TELANGANA STATE POWER GENERATION CORP. LTD. 5x800 MW YADADRI Thermal Power Station TATA CONSULTING ENGINEERS LIMITED BANGALORE, INDIA	
BHARAT HEAVY ELECTRICALS LTD. PROJECT ENGG. MANAGEMENT NOIDA	DRN: AK/ADK/sd/- CHD: NS/VKY/sd/- APPD: AK/sd/-	NAME: SD/- DATE: 29.04.18 DATE: 02.04.18 DATE: 04.04.18	TITLE: MECHANICAL GA OF CW & ACW PUMP HOUSE (FOR STAGE-I: UNIT# 1 & 2) UNIT: MM SCALE: BHEL DWG. NO. 1 PE-DG-417-165-N004 SHEET (1 OF 2)
02. REVISED INLINE WITH CUSTOMER COMMENTS 01. REVISED INLINE WITH CUSTOMER COMMENTS	ADK NS/VKY AK ADK NS/VKY AK DRAWN CHECKED APPROVED	24.12.18 08.08.18 DATE	02 01

REV.	STATUS	TYPE	REASONS FOR REVISION	DRAWN	CHECKED	APPROVED	DATE	TITLE	SCALE	UNIT	MM
02	REVISED	IN LINE	WITH CUSTOMER COMMENTS	ADK	NS/ARY	AK	24.12.18	MECHANICAL GA OF CW & ACW PUMP HOUSE (FOR STAGE-II, UNIT - #3, 4 & 5)	NA	BHEL	DWG. NO. PE-DG-417-165-N004 (SHEET 2 OF 2)
01	REVISED	IN LINE	WITH CUSTOMER COMMENTS	ADK	NS/ARY	AK	08.08.18

**Replies to comments on Mechanical GA of CW Pump house (Rev 01)**

CWP SECTIONAL VIEW -'A-A'

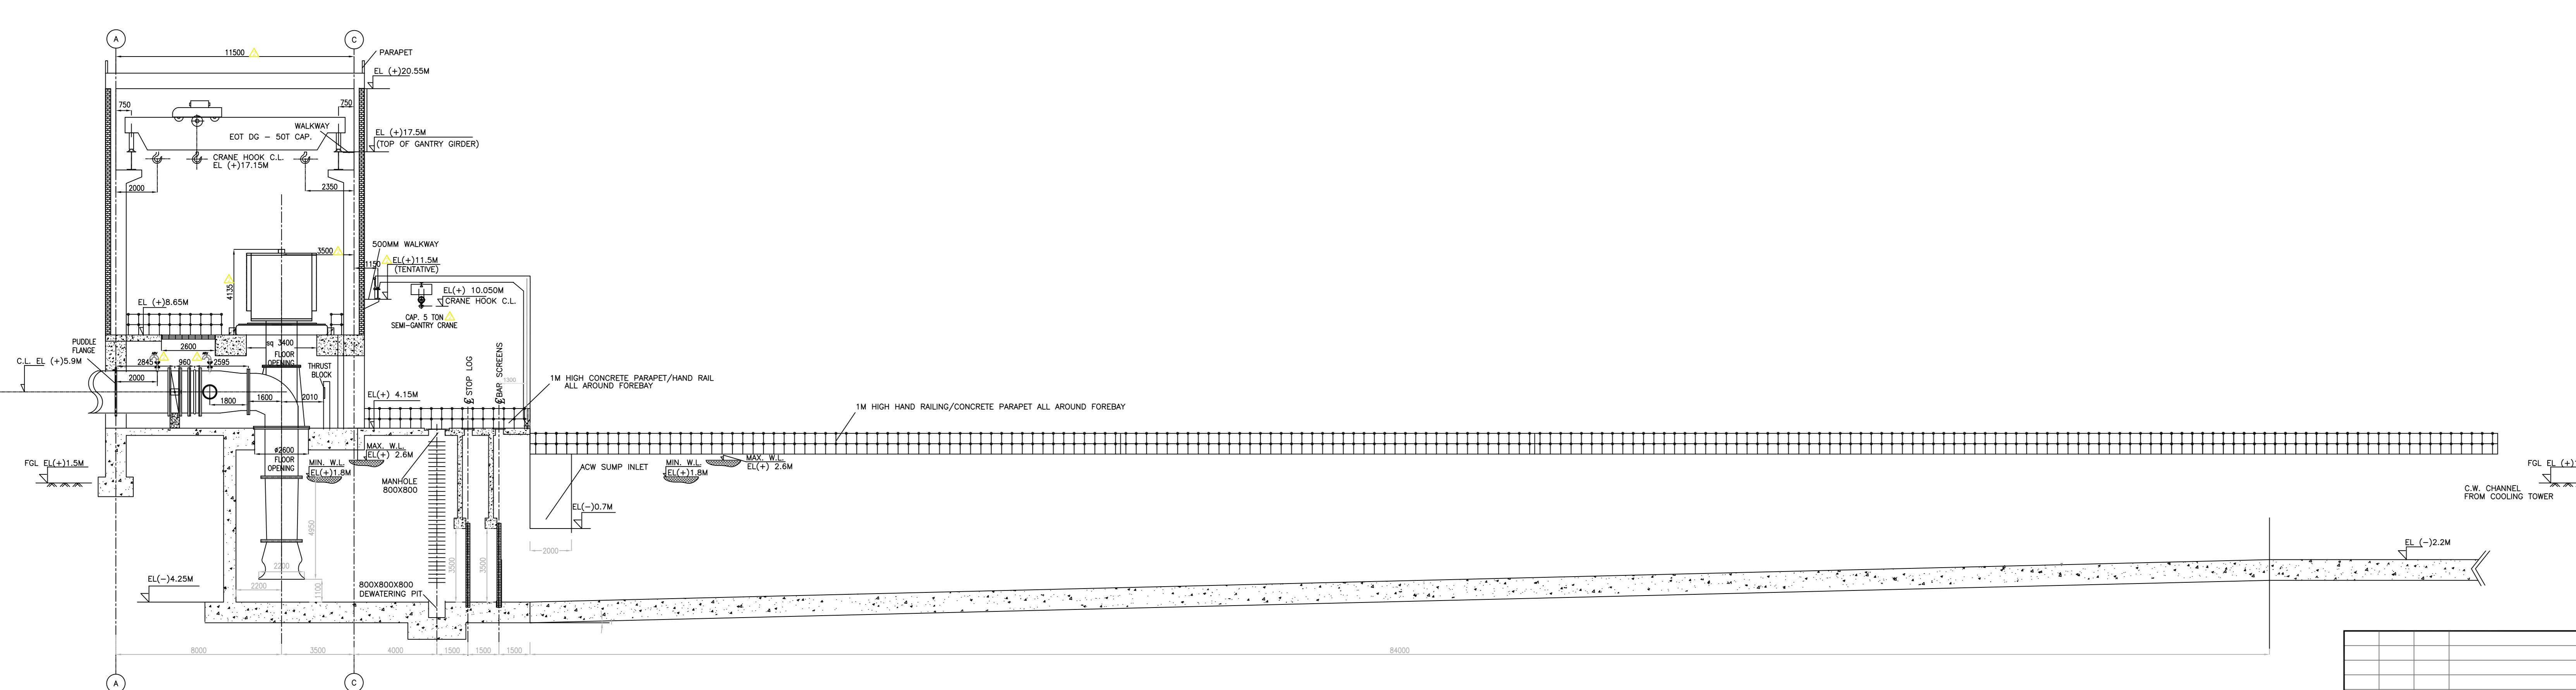
17	Pump data indicating the pump capacity, head, quantity shall be provided.	Noted & incorporated.
18	Indicate ventilation system requirement like fan and louver details shall be shown.	Ventilation system requirement shall be indicated in Architectural drawing of CW pump house (Drg no. PE-DG-417-653-C002, PE-DG-417-653-C003 & PE-DG-417-653-C004)
19	BHEL to indicate the holds as most of the equipments are to be order and are dependent on Vendor information. BHEL to indicate the same.	Noted.
21	Please mark water levels.	Water levels are already marked in CWP sectional view A-A. Further there is negligible pressure drop of 50 mm across screen and same can not be distinguished in water levels near screen in GA drawing.
22	Please indicate minimum submergence value.	Please note minimum water level in CW pump house is selected based on minimum submergence requirement and submergence requirement of 4950 mm is already indicated in the "CWP Sectional view A-A".
